# Appendix A

## NOP Comments

FILE NO: PDC17-051

Subject: City File No. PDC17-051, San Jose Flea Market Southside Rezoning Project NOP

Draft Assumptions for Future Development of the Penitencia Creek Trail  
(Proposed Interface with Berryessa BART and adjacent areas)

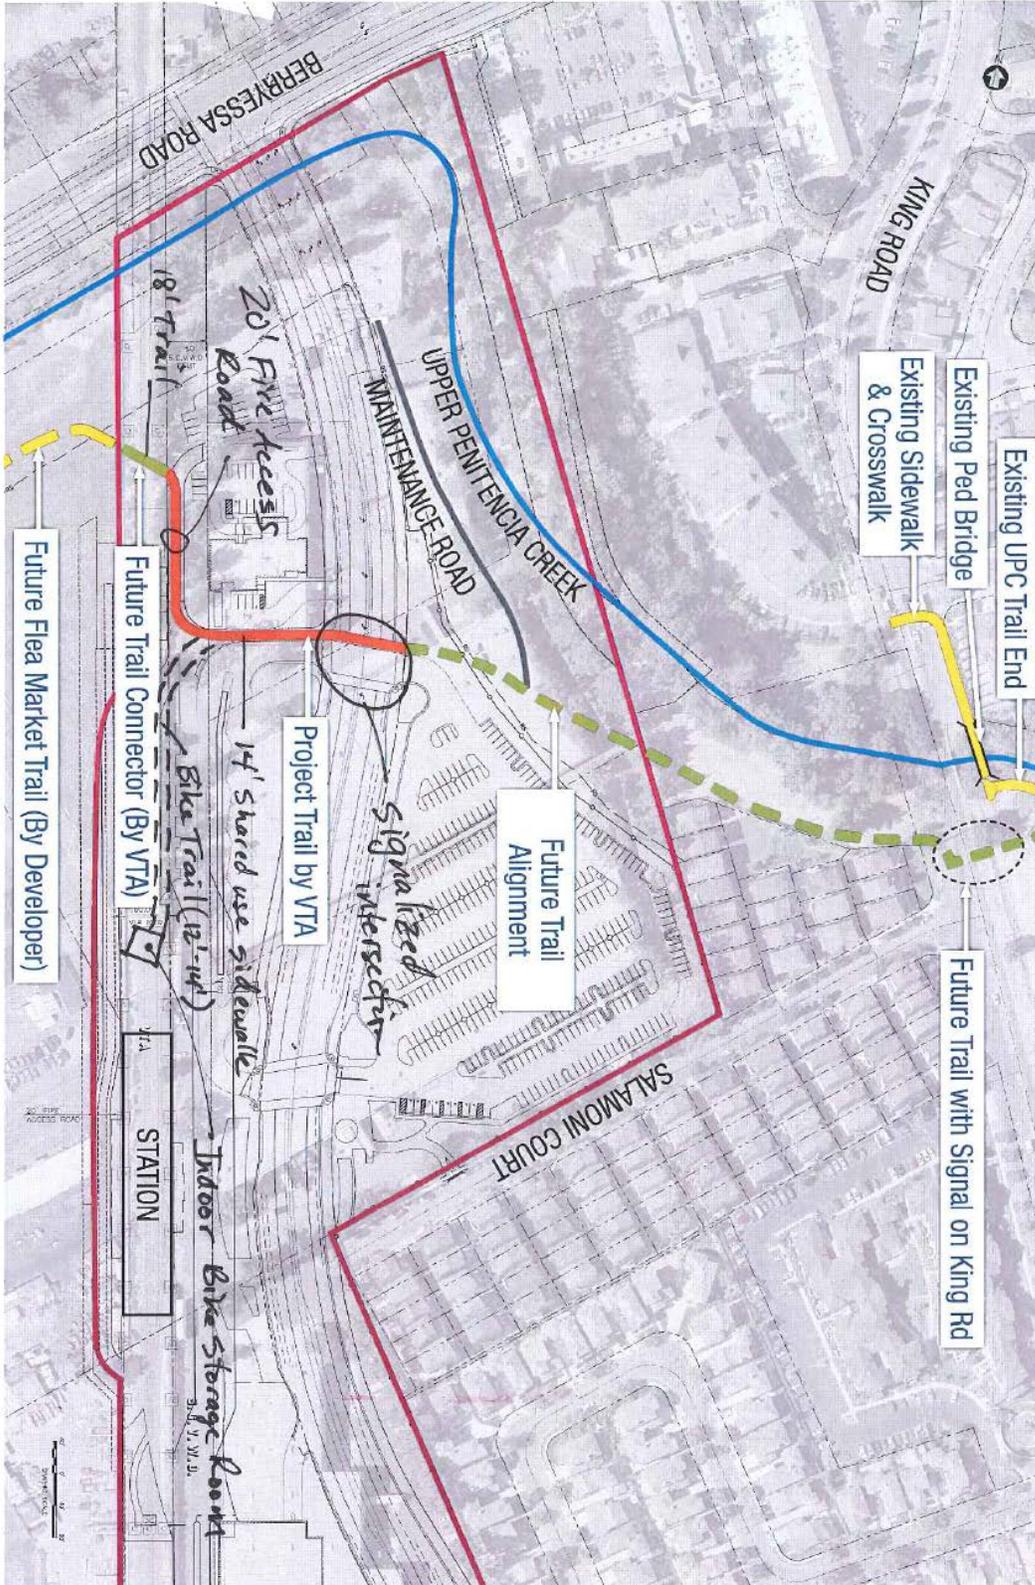
- Class I Bikeway trail development (per Caltrans Highway Design Manual and local guidelines) for the project from the north side of Berryessa Road, generally southward to Mabury Road.
- Modify existing Berryessa Road Under-Crossing to be above a 10-year flood level or better. Sustain a 12’ clearance, but height may be reduced to no less than 10’ to keep the surface above the 10-year flood elevation.
- A pedestrian/bicycle bridge may be needed for the trail to be constructed across Penitencia Creek.
- Alignment should be designed at a Top of Bank location whenever possible, and meander through open space between Sierra Road (extension) and creek channel.
- Develop the trail per the Council-approved Coyote Creek Trail Master Plan:  
<https://sanjoseca.gov/DocumentCenter/View/9350>

- Class I Bikeway trail development along the south side of Penitencia Creek from the existing trail improvements at Berryessa Station Way to the confluence with Coyote Creek.
- Ensure development of under-crossings beneath proposed roadways to be above a 10-year flood level or better with at least a 12’ clearance where ever possible after maintaining flood level clearance.
- There are no recent master plans for work in this area, but attached graphic depicts draft assumptions at the time that the Berryessa Station Way to King Road trail was developed. The design assumption is that the trail will follow the south bank of the creek. This approaches connects with existing trail infrastructure and provides the greatest recreational and public safety benefit for adjacency to new developments.
